SUBJECT: WILLOW BRANCH (PHASE II) CANAL REHABILITATION-REBID

CITY OF JACKSONVILLE
DEPARTMENT OF PUBLIC WORKS
ENGINEERING DIVISION
CONSTRUCTION CHANGE ORDER

Change Order No. Five (5) November 2, 2021

Description of Project Willow Branch Phase III Canal Rehabilitation- Rebid

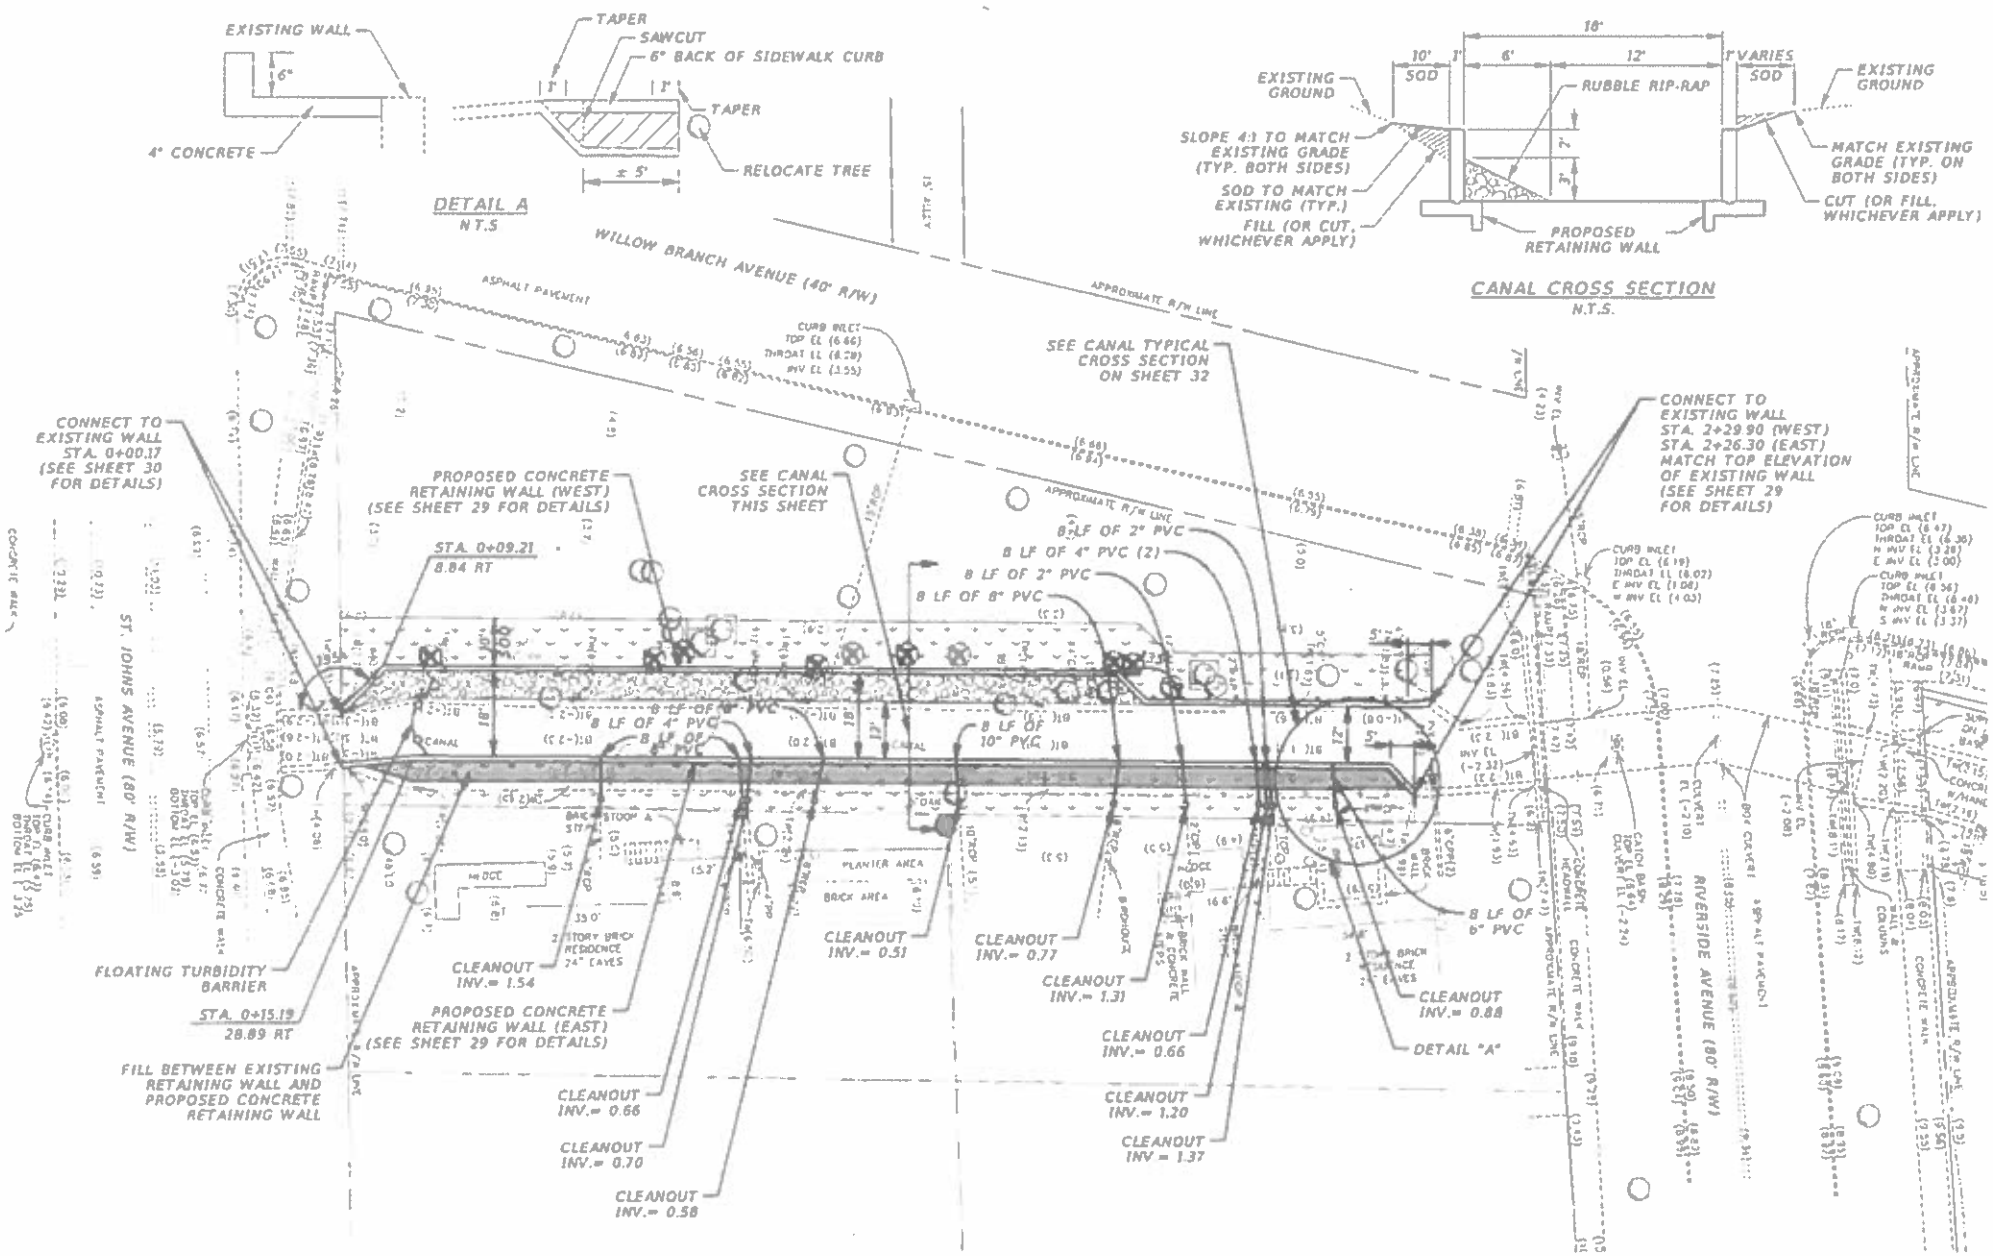
NBR	MASTER ITEM DESCRIPTION	QUANTITY	UOM	UNIT COST	NET ADDITION	NET DELETION	TOTALS
	ADDITIONAL SCOPE: Additional measures to combat erosion from rain events.						
1	LANDSCAPING EROSION REPAIR						
	RELOCATE TREE CREPE MYRTLE	1	EA	$1,350.00	$1,350.00		
	EROSION MAT EXCEL PP5-8	1	LS	$7,750.00	$7,750.00		
	CONCRETE PAVEMENT W/ CURB	1	LS	$3,150.00	$3,150.00		
	STRAW WATTLE PARADIGM FIBER ROLL	251	LF	$13.00	$3,263.00

JUSTIFICATION: A major rain event occurred on June 13, 2021, and the canal water coursed over the new retaining wall and caused damage to the recently installed landscaping. The COJ had the landscaping added along the canal retaining walls through a plan revision. A portion of soil on the eastern canal bank between approximate STA 2+15 to STA 2+25 was severly eroded causing the newly planted Crepe Myrtle tree to be undermined and destabilized. This landscaping erosion issue was reviewed, and the EOR provided a detail for concrete slope pavement to be constructed in the location of the wash out. COJ Parks division requested for an erosion mat and straw wattles to be installed in the shrub beds to protect them from erosion. The contractor's quote includes the cost to furnish all labor, equipment, and materials to construct the slope pavement and install the erosion mat and straw wattles. Additionally, the quote includes cost to relocate the Crepe Myrtle that was undermined and for restoration and cleanup.

Description	Unit	Unit Price	Quantity	Amount	Comments	Determination
Relocate Tree Crepe Myrtle	EA	$ 1,350.00	1	$ 1,350.00	Access to the tree is limited and will be challenging to get equipment access to relocate the tree	Unit price is high, but reasonable with remobalization costs and given this additional work was added after completion of the project.
Erosion Mat EXCEL PPS-8	SY	$ 16 42	472	$ 7,750.00	Installation of the mat is going to be challenging with the shrubs already planted The mat will require the contractor to custom cut the mat to fit between plants and cover the entire area necessary	Unit price is reasonable with remobalization costs and given this additional work was added after completion of the project.
Concrete Paving W/ Curb	LS	$ 3,150.00	1	$ 3,150.00	Access to the area is limited for equipment This work will most likely be performed by hand	Unit price is high, but reasonable with remobalization costs and given this additional work was added after completion of the project.

Wattle 9" Straw Wattle Sediment Fiber Roll Paradigm	LF	$ 13.00	251	$ 3,263 00		Unit price is high, but reasonable with remobalization costs and given this additional work was added after completion of the project.
TOTAL				$ 15,513.00
